Case #H 93-172, 1103 Canyon Road. Downtown and Eastside Historic District. Justin Greene, agent for Dirk Wales, proposes a one-story addition to West elevation of existing residence.

Case #H 93-172

**PROPOSAL:** One-story addition to West elevation of existing residence.

DATE: August 24, 1993  
TO: Historic Design Review Board Members  
FROM: Mary Grzeskowiak, Urban Design Review Specialist  
Ian Cordwell, Urban Design Review Specialist *MG*

NORTH ELEVATION

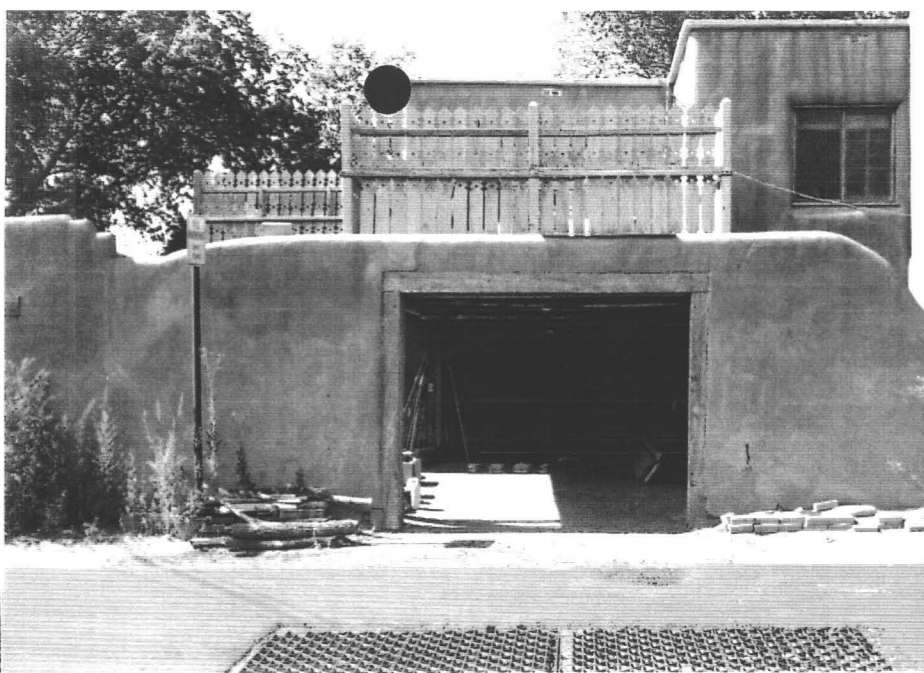
On the north elevation, which faces Patrick Smith Park, the applicant proposes to replace an existing door with a new Dutch door, add a 2'-6" parapet to an existing yard wall, rebuild an existing bridge, and install a new window (approximately 3'-6" x 4'-0") where the applicant suggests a previous window had existed.

NORTH / PATRICK SMITH PARK ELEVATION 1/4" = 1'-0"

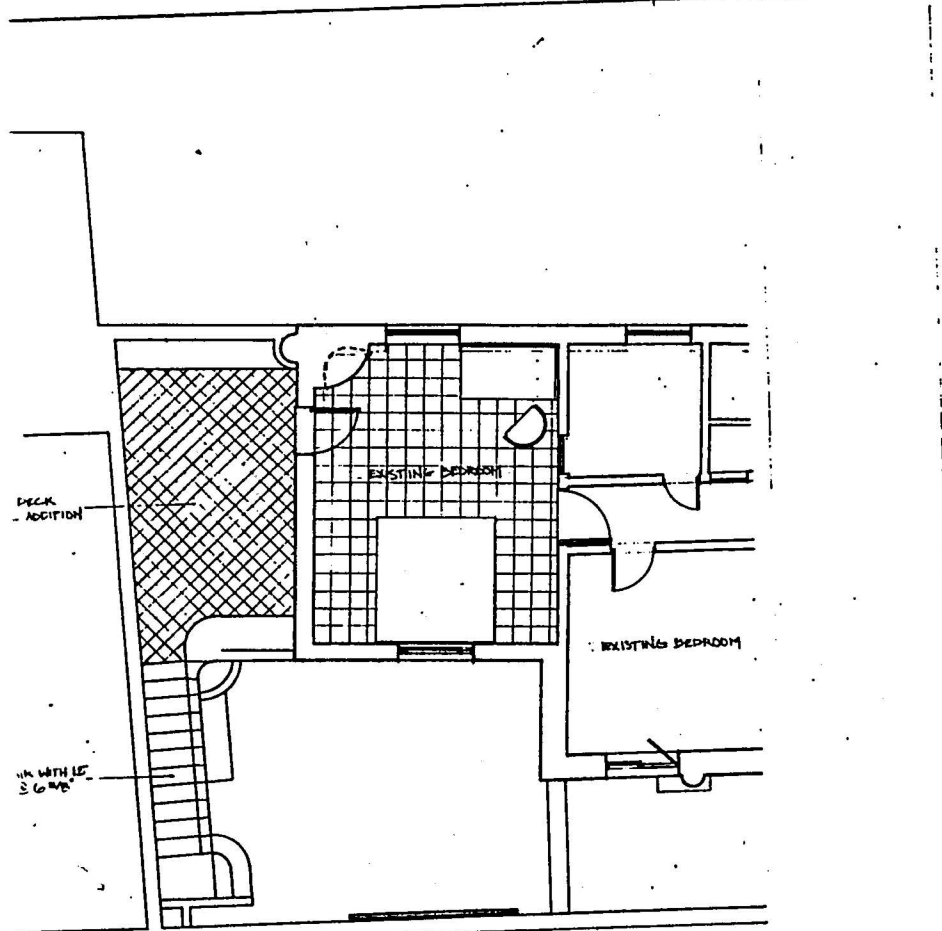
Chair Woods asked the applicant to address the staff's concern with making the window larger than it had been originally. Mr. Greene stated that the window that had been previously infilled was about 2 1/2' x 2 1/2'. Chair Woods stated that he was then proposing a larger window at this location. Mr. Greene stated that they were in order to match in size and scale the other windows on that elevation. Chair Woods stated that the staff's concern was that the window opening was going to be made bigger and the that the applicant's answer to that was that he was trying to repeat the windows that are existing on that facade, and asked the staff to address this. Mr. Cordwell stated that his concern was that the actual opening was more in keeping with the window on the same floor level, which is adjacent to it, and the applicant should try to match the fenestration pattern of that window and not the window above it. Ms. Grzeskowiak stated that this is based on the ghost mark that exists today, and that it appeared from the outside that the window width was more with keeping with the window that is existing to the left more than the window that is directly above it. Mr. Greene stated he had taken the height from the window to the left and the width of the window above and used a combination of the two.

It was noted that the drawing of the window on the North elevation showed a three-over-one window unit where there is, at present, a six-over-one unit, and Mr. Cordwell asked Mr. Greene if this was just drawn wrong, or it was a proposed change. Mr. Greene agreed it was drawn in error.

Although the applicant has provided pictorial evidence of a previous window, as per SFCC 14-70.73(E)(2), the proposed unit would appear to be considerably larger than the previous opening. In addition, the proposed unit violates SFCC 14-70.9(B)(3) in that the glazing exceeds 30" in certain dimensions.

Staff notes that the proposed north elevation drawings indicate a three-over-one window unit adjacent to the proposed opening where there is, at present, a six-over-one unit. If replacement is indeed warranted, staff recommends that the HDRB mandate replacement of the existing unit in-kind, as per SFCC 14-70.73(E)(2).

Mr. Martinez moved to approve **Case #H 93-172** with the condition that the new window be replaced to match the window opening size of the window adjacent to (East of) the new window. Mr. Bennett seconded the motion and it was passed by unanimous voice vote.

This is to certify that the Historic Design Review Board at their meeting on August 24, 1993, acted on the above referenced case. The decision of the Board was to  approve,  conditionally approve,  table,  deny your request. You shall make part of your Building Permit application any conditions imposed by the Board which are listed as follows: The new window on the north elevation must match the configuration and size of the existing window immediately to the east.
